Subject: Correction

This notice is intended to inform users of a correction made to CLSI document EP17-Ed2-IG, *Evaluation of Detection Capability Implementation Guide*, 1st ed. The correction is described below and shown as red text in the figure excerpt.

### Verification of Detection Limits:

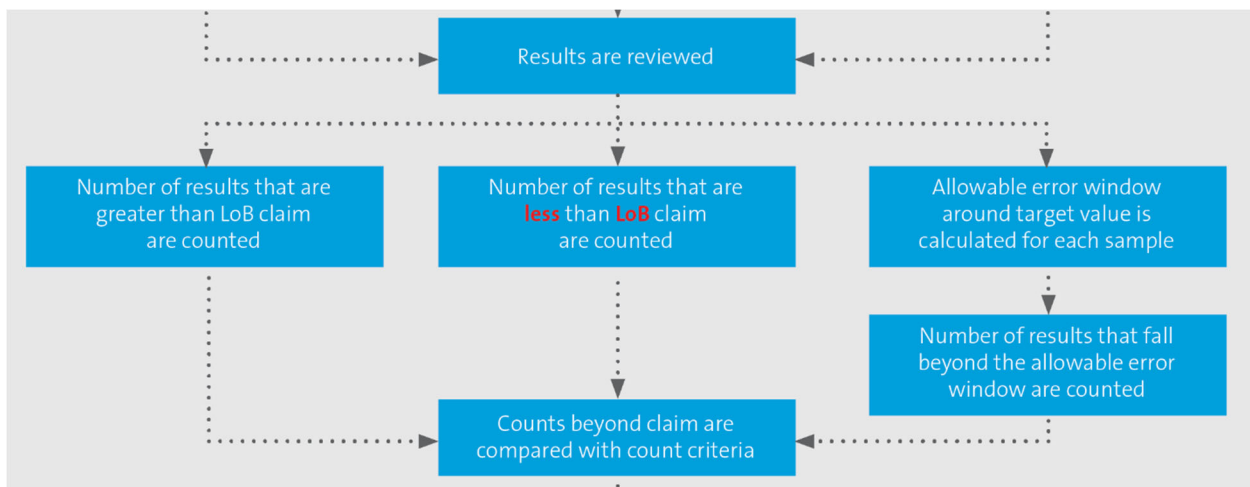
A box in the process flow chart is listed incorrectly as “Number of results that are greater than LoD claim are counted.” The box in the process flow chart has been corrected to read “Number of results that are less than LoB claim are counted.”
